PIC18FXX2 Rev. B2 Silicon/Data Sheet Errata

The PIC18FXX2 parts you have received conform functionally to the Device Data Sheet (DS39564B), except for the anomalies described below.

The following silicon errata apply only to PIC18FXX2 devices with these Device/Revision IDs:

FIGURE 1: PINOUT DIAGRAM FOR 44-PIN QFN PACKAGE

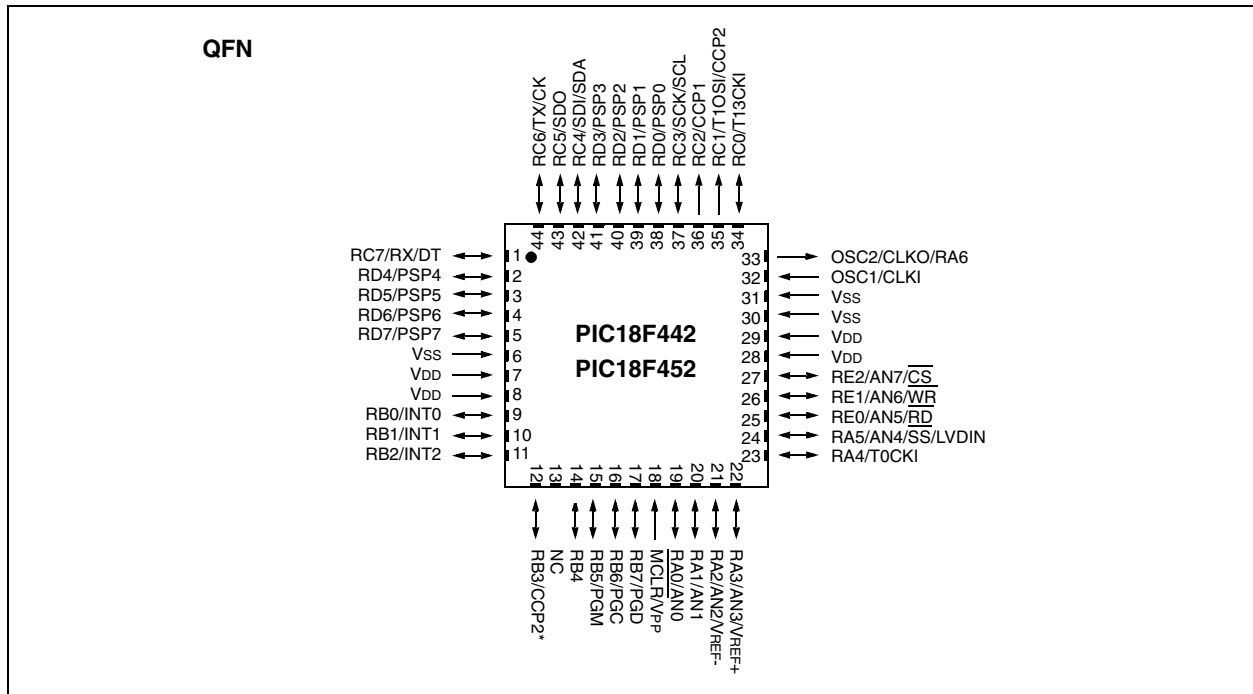
1. The “Pin Diagrams” on pages 2-3 of the Data Sheet are amended with the addition of the 44-pin QFN pinout, shown in Figure 1.
2. Table 1-3 of **Section 1.0 “Overview”** is replaced with an updated version which adds a column for QFN pin assignments. A row is also added for previously unlisted NC pins. All new information is indicated in **bold**.

FIGURE 1: PACKAGE MARKING TEMPLATE FOR PIC18F442/452, 44-PIN QFN

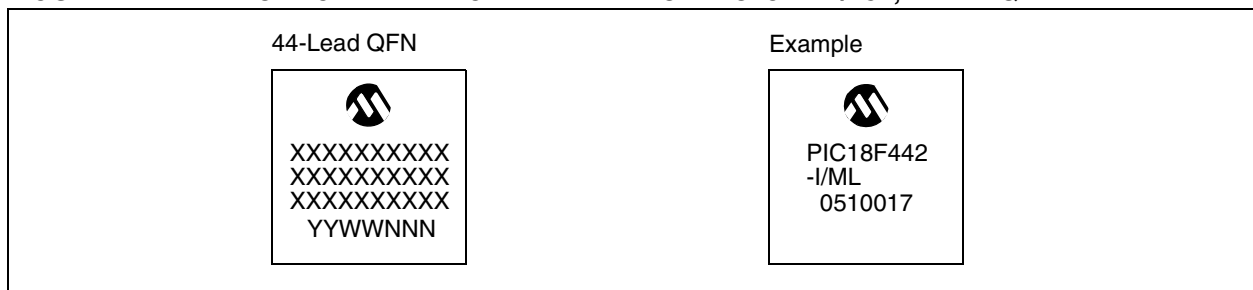
3. **Section 24.1 “Package Marking Information”** is amended to include a marking template and example for 44-pin QFN devices. These are shown in Figure 1.

FIGURE 2: 44-PIN QFN PACKAGE

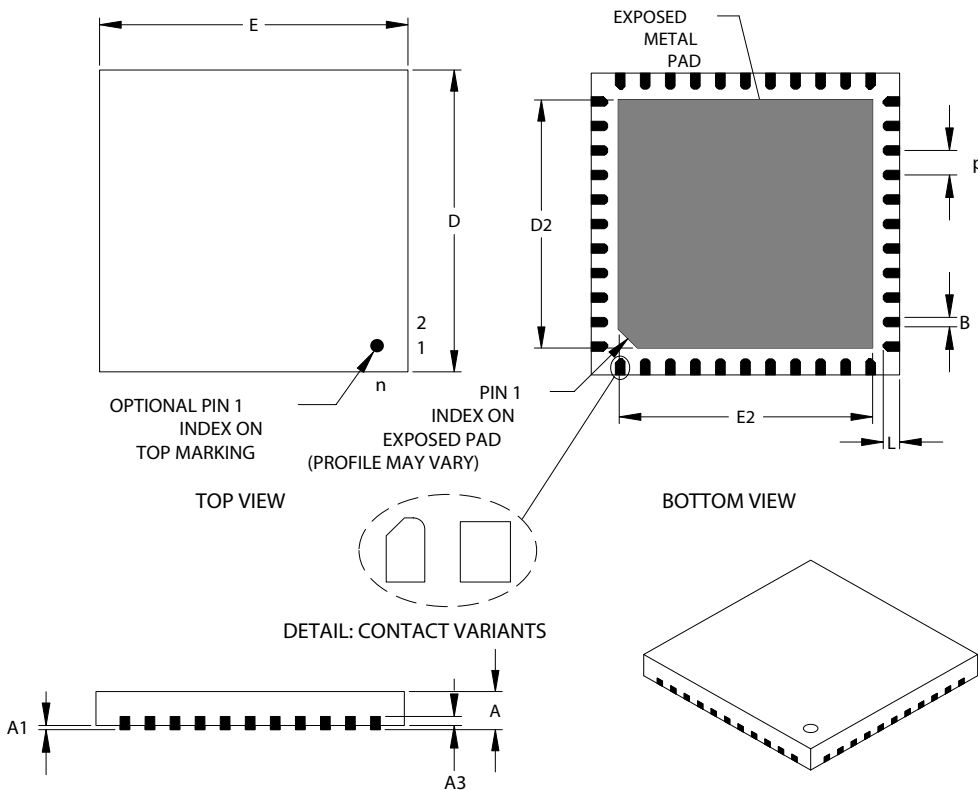
4. **Section 24.2 “Package Details”** is amended to include the mechanical drawing of the 44-pin QFN package following the existing drawings. This is shown in Figure 2.
